CITY OF MADISON

PLAN OF PROPOSED IMPROVEMENT

N FRANKLIN AVENUE & LYNN TERRACE - ASSESSMENT DISTRICT 2025

CITY PROJECT NO. 15113
CONTRACT NO. 8766

15113	MADISON, WI	8766	CONTRACT NO:
N FRANKLIN AVENUE PLAN & PROFILE			
N FRANKLIN AVENUE & LYNN TERRACE - ASSESSMENT DISTRICT 2025			
M:\DESIGN\Projects\15113\CAD\Streets\15113EN-PnP.dwg			
15113			
P-3

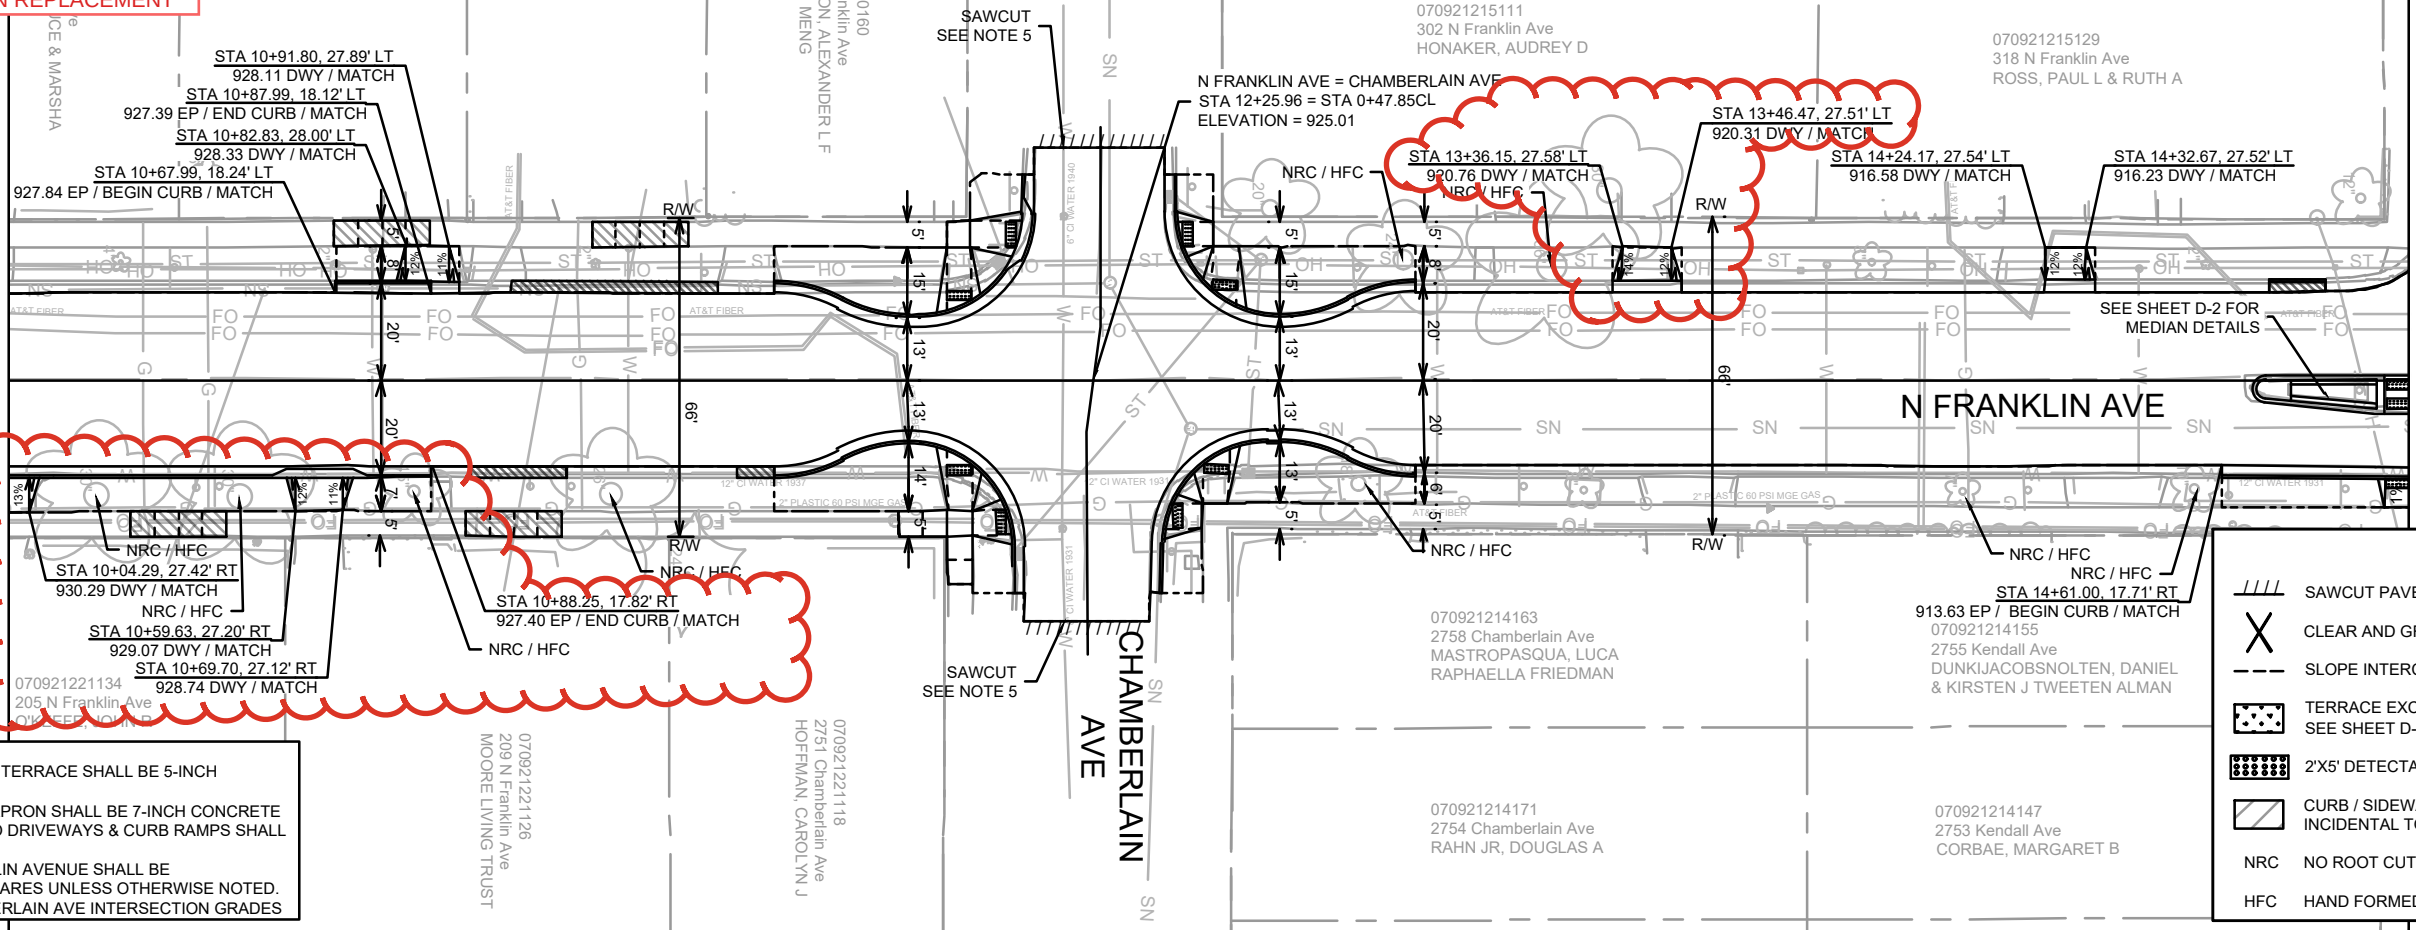
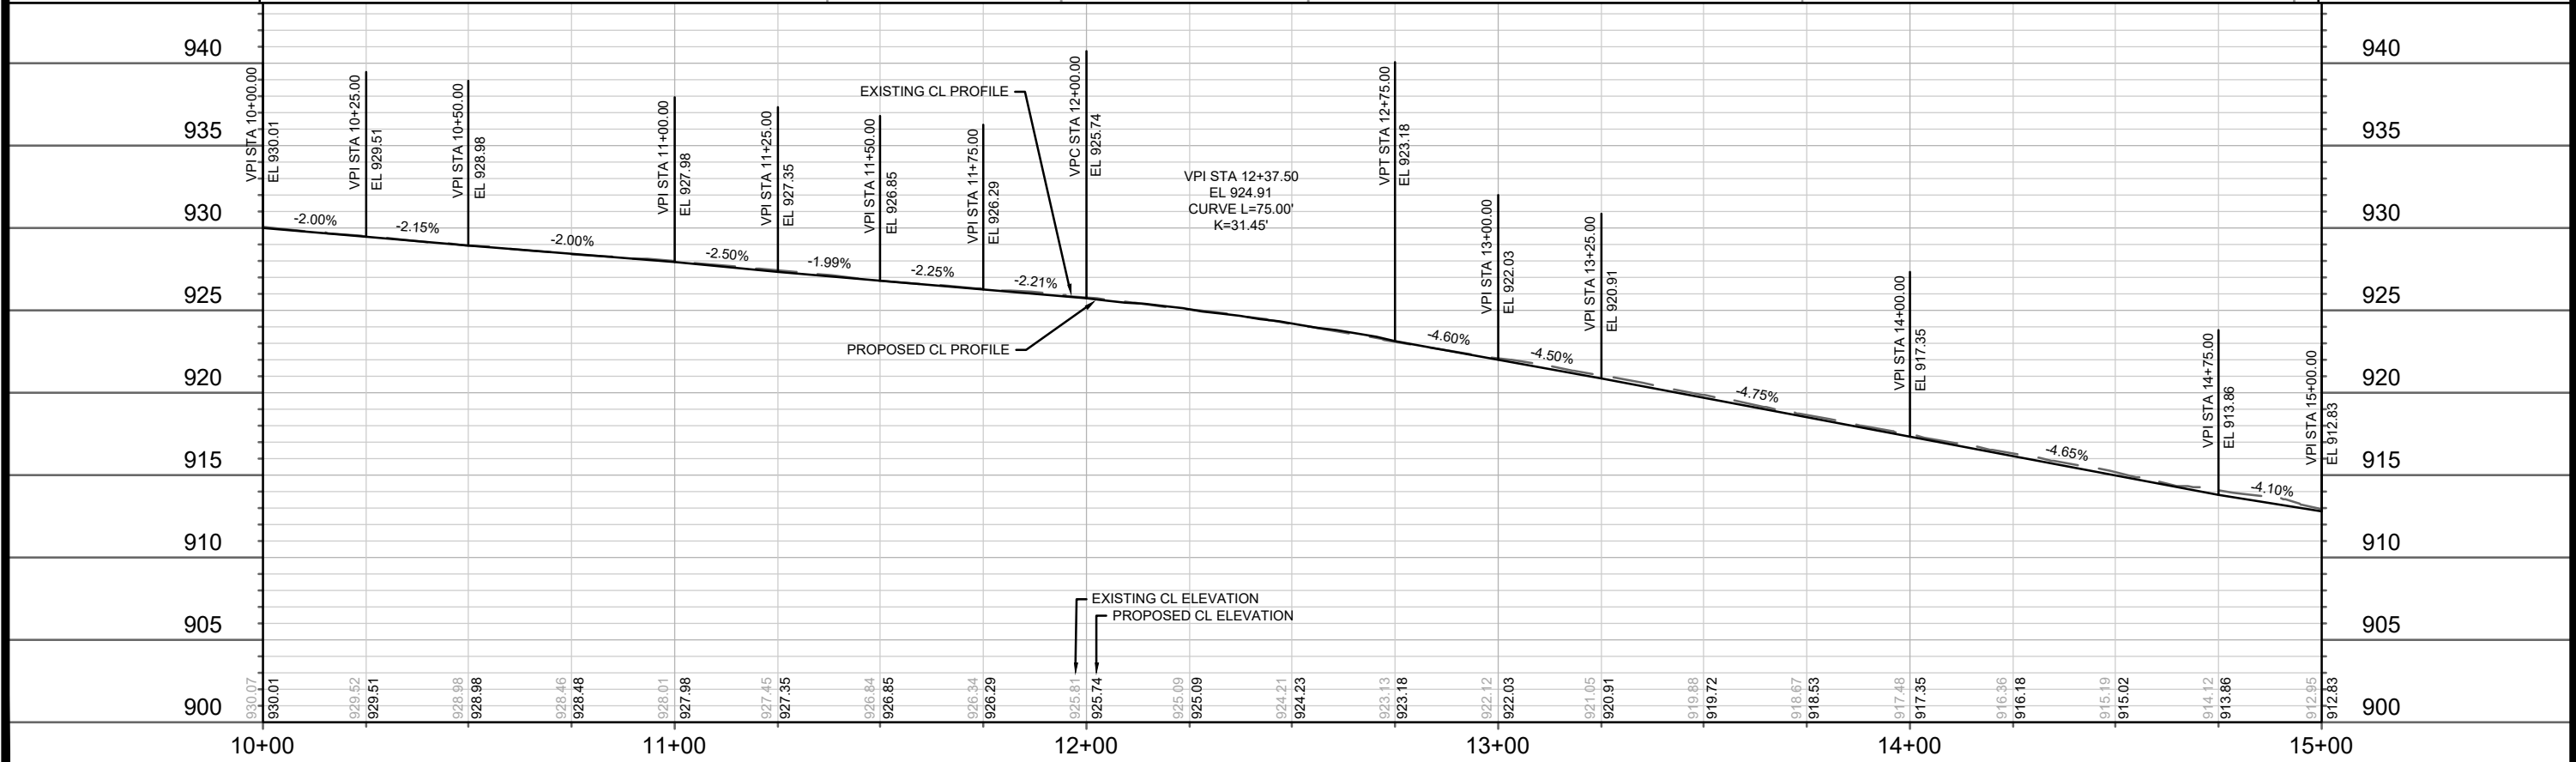
ADDENDUM 1 - GCIT - 02/11/2025
- UPDATED CL PROFILE

REVISION 1 - GCIT - 04/03/2025
- UPDATED CURB REPLACEMENT LIMITS
- ADDITIONAL DWY APRON REPLACEMENT

15113	15113	U-2
N FRANKLIN AVENUE PLAN & PROFILE		
N FRANKLIN AVENUE & LYNN TERRACE - ASSESSMENT DISTRICT 2025		
MADISON, WI		
CONTRACT NO: 8766		
M:\DESIGN\Projects\15113\CAD\Sewers\15113SWR-PipeNetwork.dwg		
15113		
U-2

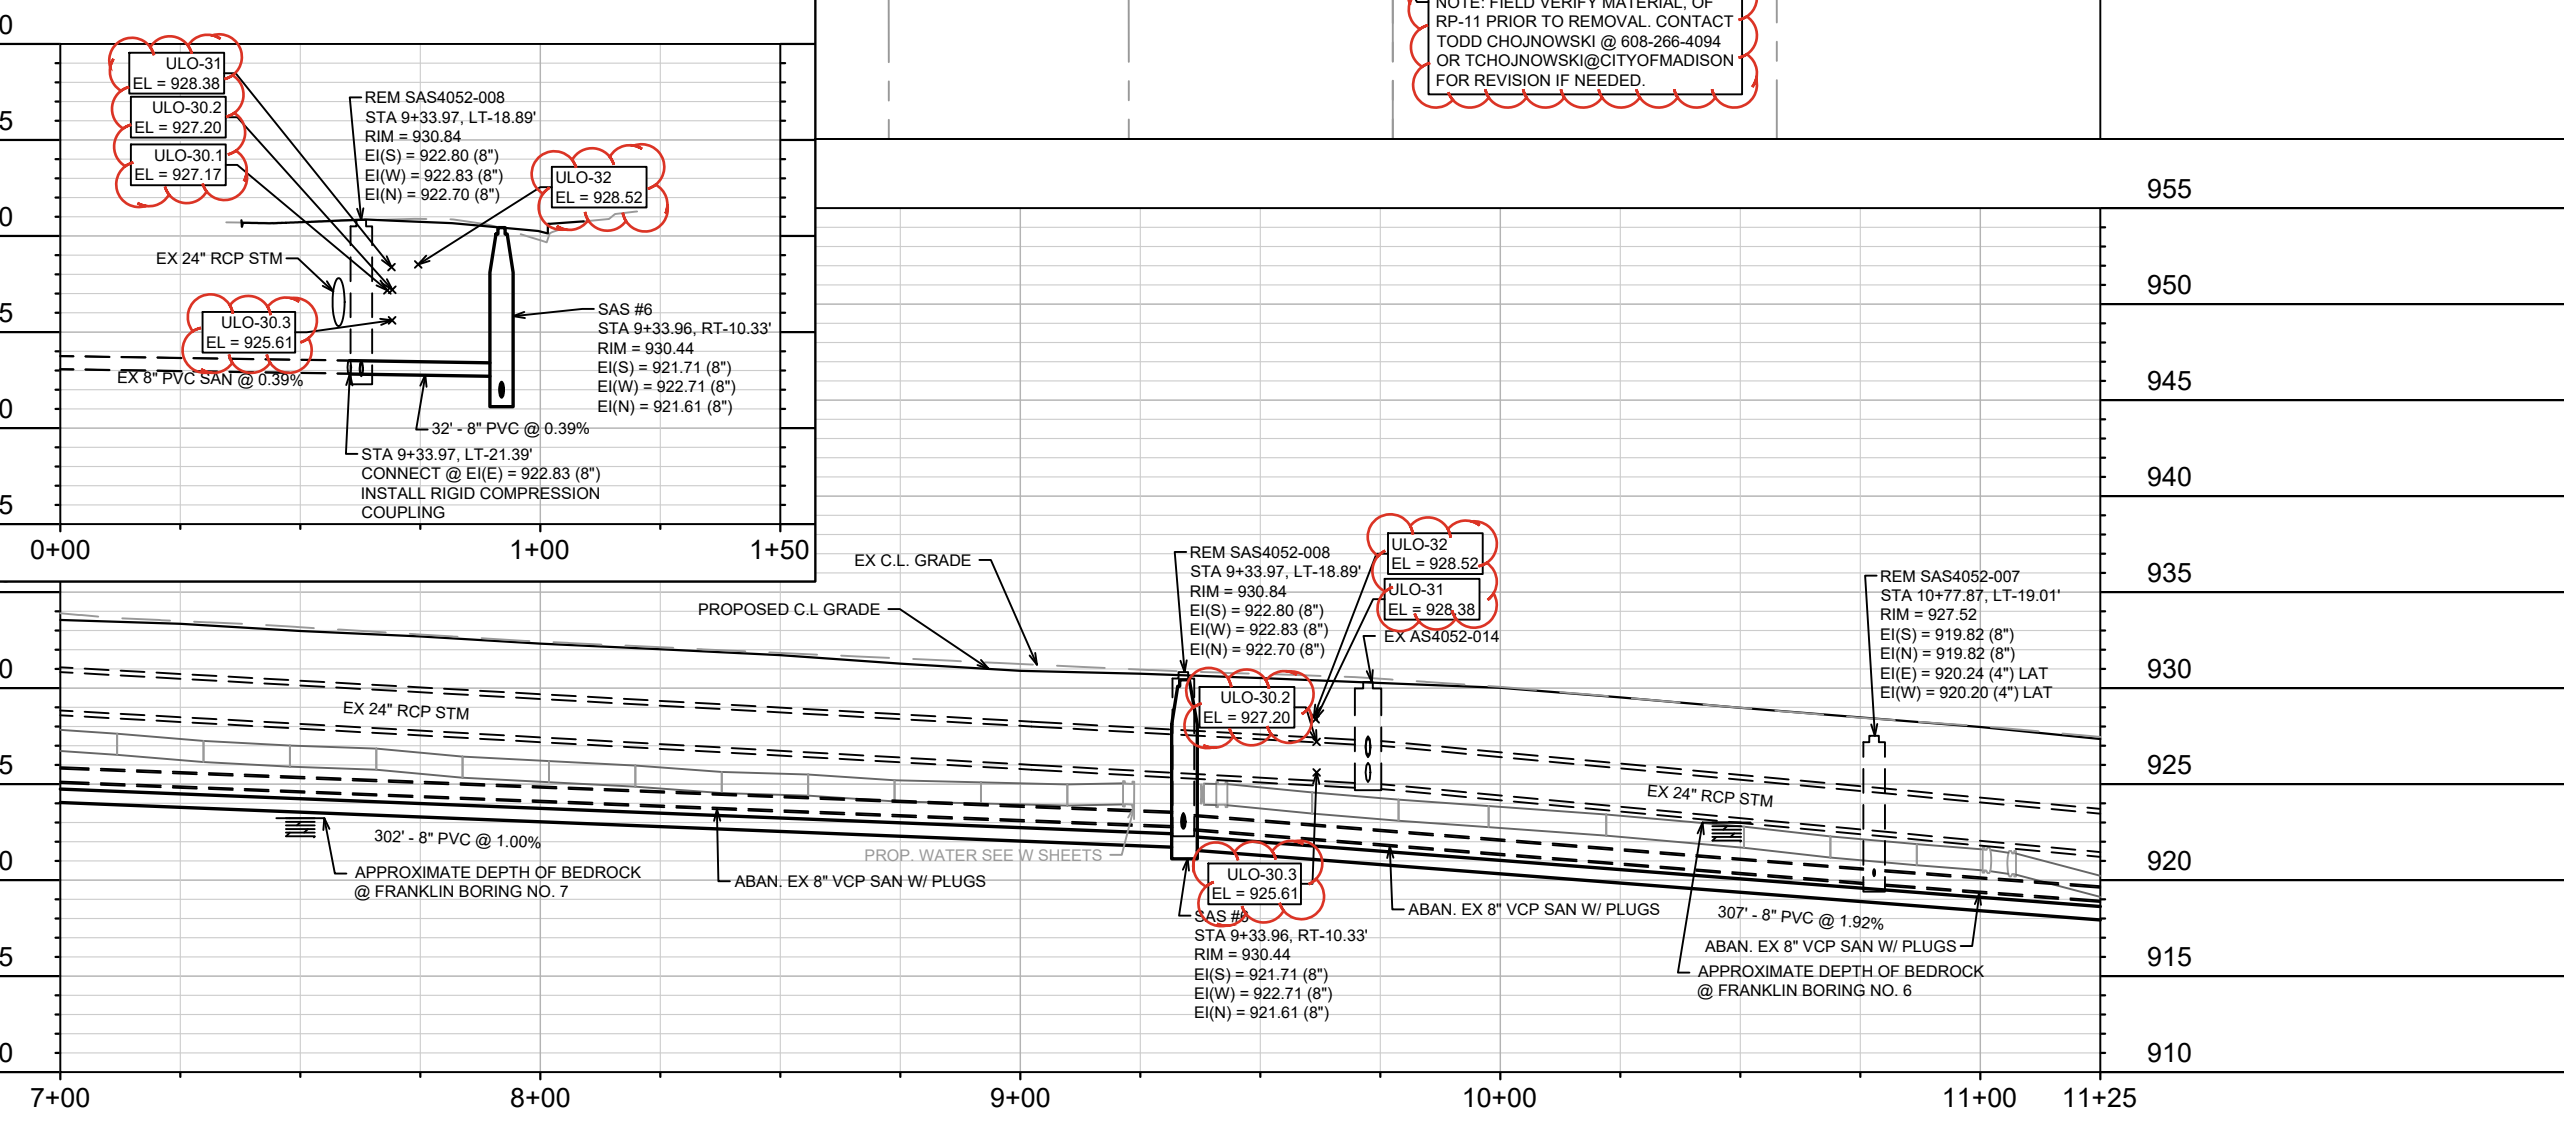
REVISION 2: TAC
4/21/2025
ULO UPDATES &
CHANGES TO
STORM AND SAN

MARK	REVISION	DATE	BY
15113	W-2	4/21/2025 2:29 PM	W-2

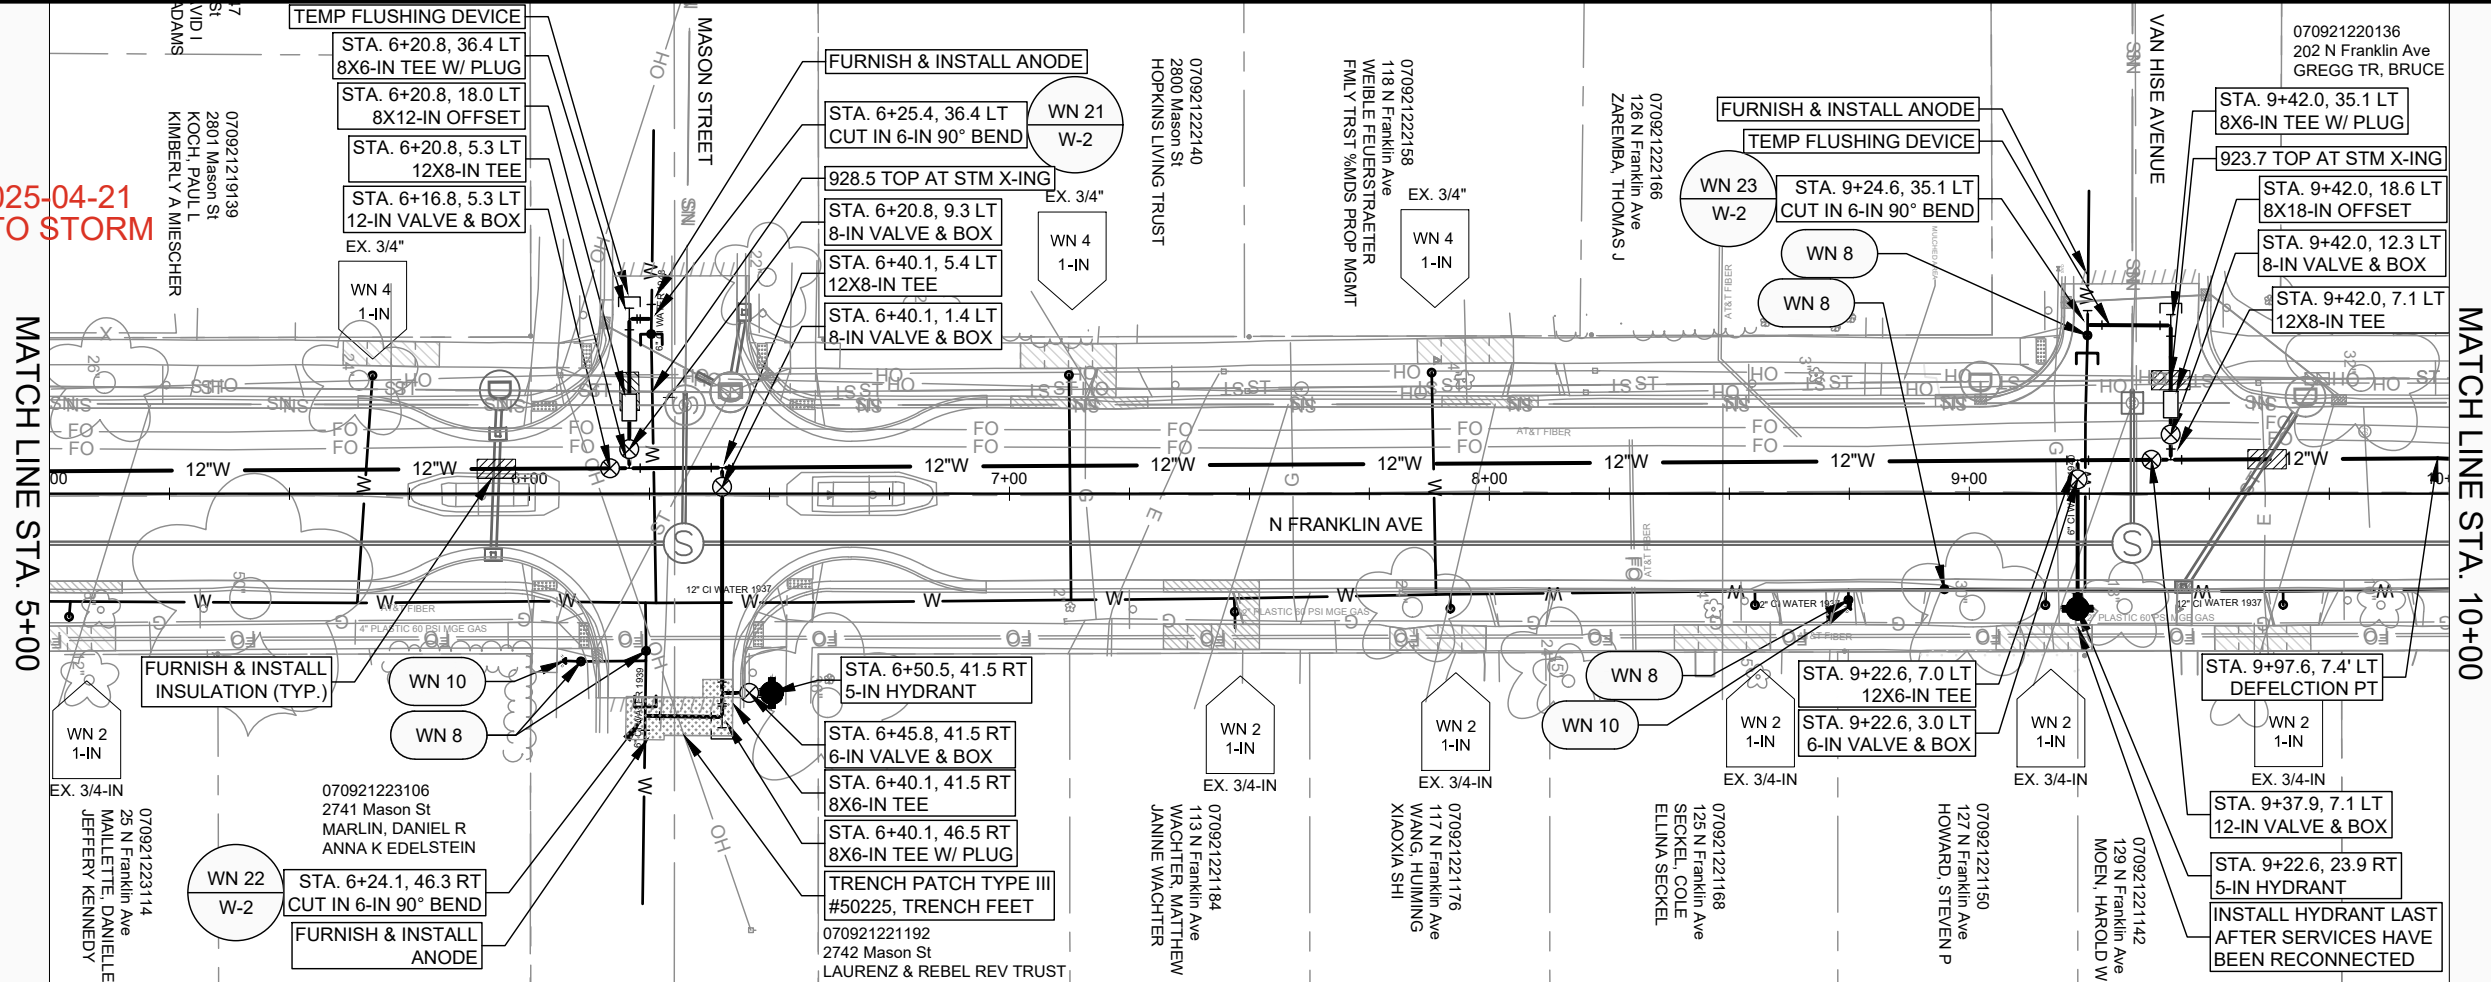
REVISION 2: 2025-04-21
ULO UPDATE TO STORM
AND SAN
